## RESPONSES TO DTSC COMMENTS ON THE FEASIBILITY STUDY AND REMEDIAL ACTION PLAN

**RESPONSES TO DTSC GSU COMMENTS (dated November 16, 2011)  
ON THE FEASIBILITY STUDY (REDLINE 07/27/11) AND REMEDIAL ACTION PLAN (REDLINE 07/27/11)  
Former Pechiney Cast Plate, Inc. Facility  
3200 Fruitland Avenue  
Vernon, California**

**RESPONSES TO DTSC ENGINEERING COMMENTS (DATED DECEMBER 20, 2011)  
ON FEASIBILITY STUDY (REDLINE DATE 7/27/2011) AND REMEDIAL ACTION PLAN (REDLINE DATE 7/27/2011)  
FOR FORMER PECHINEY CAST PLATE SITE, VERNON, CALIFORNIA  
Former Pechiney Cast Plate, Inc. Facility  
3200 Fruitland Avenue  
Vernon, California**

**RESPONSES TO DTSC HERO COMMENTS (DATED SEPTEMBER 27, 2011)  
ON THE REMEDIAL ACTION PLAN (REDLINE 072711)  
Former Pechiney Cast Plate, Inc. Facility  
3200 Fruitland Avenue  
Vernon, California**

DISTRIBUTION OF PCE TO TCE  
IN SOIL VAPOR AT 5 FEET  
Former Pechiney Cast Plate, Inc., Facility  
3200 Fruitland Avenue  
Vernon, California

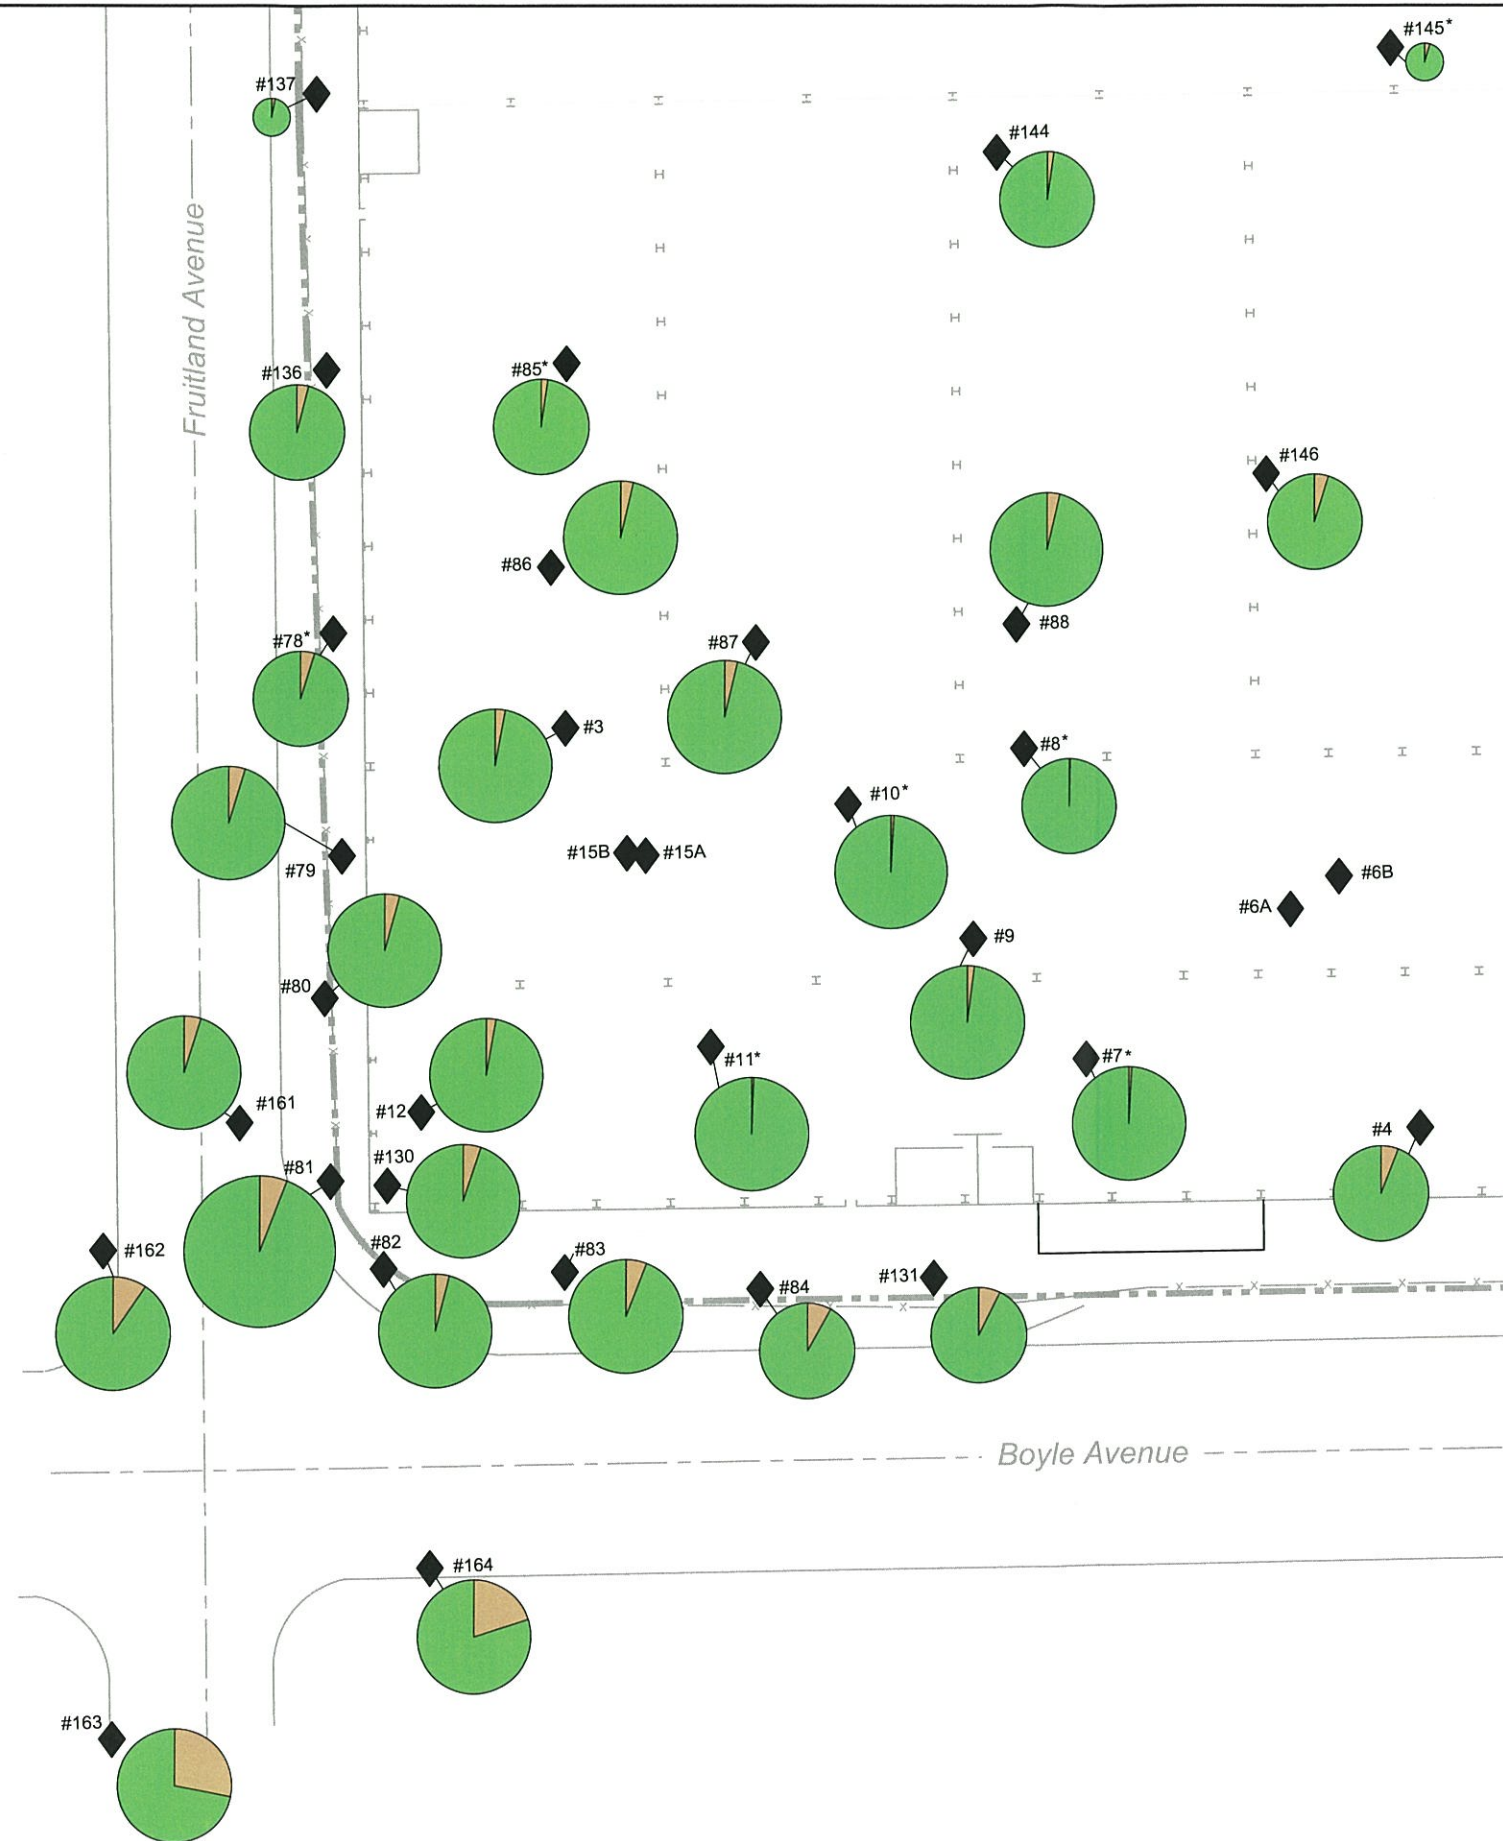
<p>GSU #2. The FS identifies that the offsite vapor concentrations exceed indoor air standards, and the contaminant vapor plume does not appear to be fully delineated. While DTSC recognizes the potential for comingling contaminant sources, the Site owner is still responsible for characterizing the full extent of the site derived contamination, and for demonstrating their contribution to the comingled plume. This issue needs to be resolved. The author recommends a meeting between DTSC and all interested parties, to discuss a follow up plan of action for supplemental vapor plume characterization.</p>	<p>The extent of the site-derived soil vapor impacts has been sufficiently assessed to support the proposed remedy for the northwestern portion of the Site (also referred to as the Phase I area). The proposed remedy for VOCs in soil and soil vapor in this portion of the Site, as presented in the Draft RAP, includes the placement of shallow and deep soil vapor extraction (SVE) wells on-site near the site boundary to address site-derived VOCs in soil vapor along Fruitland and Boyle Avenues directly adjacent to the Site (for Figures 6 and 7 of the Draft RAP, <b>see TAB 23 and TAB 24</b>). The anticipated radius of influence, although conservatively estimated as 60 feet (shallow zone) and 85 feet (deep zone), will capture site-derived VOCs (e.g., TCE) in soil vapor along Fruitland and Boyle Avenues, along with VOCs associated for other off-site sources.</p> <p>Based on the off-site soil vapor testing conducted in July 2009 (discussed in Section 3.6 of the Draft FS [<b>see TAB 2</b>], data included in Appendix A of Draft FS [<b>see TAB 12</b>], and attached as Table 2 for reference), the sample results indicated the following:</p> <ul style="list-style-type: none"> <li>• TCE and PCE were detected in all shallow soil vapor samples (locations #161 through #164) at depths of 5 and 15 feet. Other VOCs, 1,1,1-trichloroethane (1,1,1-TCA; #163 at 15 feet) and 1,1-dichloroethene (1,1-DCE; #164 at 15 feet) were detected in only one sample each. No other VOCs were detected.</li> <li>• TCE soil vapor concentrations decreased to the north, northwest (with the exception of the 15-foot sample at #164), and west of the Site, while the PCE soil vapor concentrations increased. TCE and PCE soil vapor concentrations also increased with depth. Assuming the suspected on-site source area for the site-derived TCE is present in the northwest corner of the Site, a threefold decrease in the concentration of TCE in soil vapor was measured between the on-Site sample location #81 and the off-site sample location #162, approximately 60 feet north. This reduction in concentration was also observed to the west between on-Site sample location #82 and off-site sample location #164. Based on this observation, the site-derived VOCs will continue to decrease at further distances from the Site and co-mingle with other source(s) in a highly industrial area.</li> <li>• The detected concentrations of TCE and PCE exceed risk-based screening levels (RBSLs) for indoor inhalation exposures to commercial/industrial workers, while the detected concentrations of 1,1,1-TCA and 1,1-DCE are well below their respective RBSLs. As discussed in Sections 4.1.1, 4.2.2, and 4.2.3 of the Draft FS (<b>see TAB 3, TAB 5 and TAB 6, respectively</b>), the RBSLs are considered protective of potential exposures to indoor workers at adjacent commercial/industrial facilities near the off-site sample locations, and outdoor utility workers performing trench work (semi-confined air space) in Fruitland or Boyle Avenues.</li> </ul>

DTSC GSU SPECIFIC COMMENTS AND RECOMMENDATIONS	RESPONSE
	<ul style="list-style-type: none"> <li>The highest PCE soil vapor concentration was detected at the furthest point from the Site on Fruitland Avenue (at sample point #163, see Figure 2). At this sample location, the TCE concentration in the 15-foot sample also was higher than the 15-foot sample results obtained for TCE at the two off-site sample locations (#162 and #164) closer to the Site. The higher PCE concentrations at the off-site sample location suggest the presence of an off-site source or sources. For example, sample point #163 is approximately 140 feet northwest of the Site, and approximately 300 feet east of the former Detrex Chemical facility (a former solvent recycling facility that was located on Fruitland Avenue and listed with a land use deed covenant<sup>3</sup>). At this former facility, a soil removal action was conducted in 2001 to a depth of 20 feet in a localized area that exhibited elevated concentrations of PCE in soil (1100 milligrams per kilogram at 4 feet) and soil vapor (34 milligrams per liter at 20 feet). Other VOCs, TCE and 1,1,1-TCA, also were detected but at a much lower concentrations. In addition, a recent investigation conducted by Tetra Tech Inc.<sup>4</sup> at a facility located on Fruitland Avenue, approximately 700 feet west of the Site also identified PCE and TCE in soil vapor. At this facility, PCE and TCE were detected in soil vapor at 5 and 20 feet below grade at concentrations up to 100 µg/L, with the highest concentration reported for PCE in a hazardous materials storage area.</li> <li>Calculated molar ratios of PCE to TCE (0.10 and 0.42) are an order of magnitude higher at three of the off-site soil vapor sample locations (#162, #163, and #164). The molar ratios calculated for the on-site samples located in the suspected on-site source area ranged between 0.01 and 0.087. The distribution of PCE to TCE is presented graphically on Figures 2 and 3. The PCE to TCE molar ratios further suggest the probability of an off-site source or sources of PCE and TCE in the vicinity of the off-site sample locations #162, #163, and #164.</li> </ul> <p>Based on the proposed remedy (SVE) for the northwestern portion of the Site, the attenuation of TCE concentrations in soil vapor with distance from the Site, and the presence of off-site source(s) indicate that further off-site investigations are not warranted.</p>
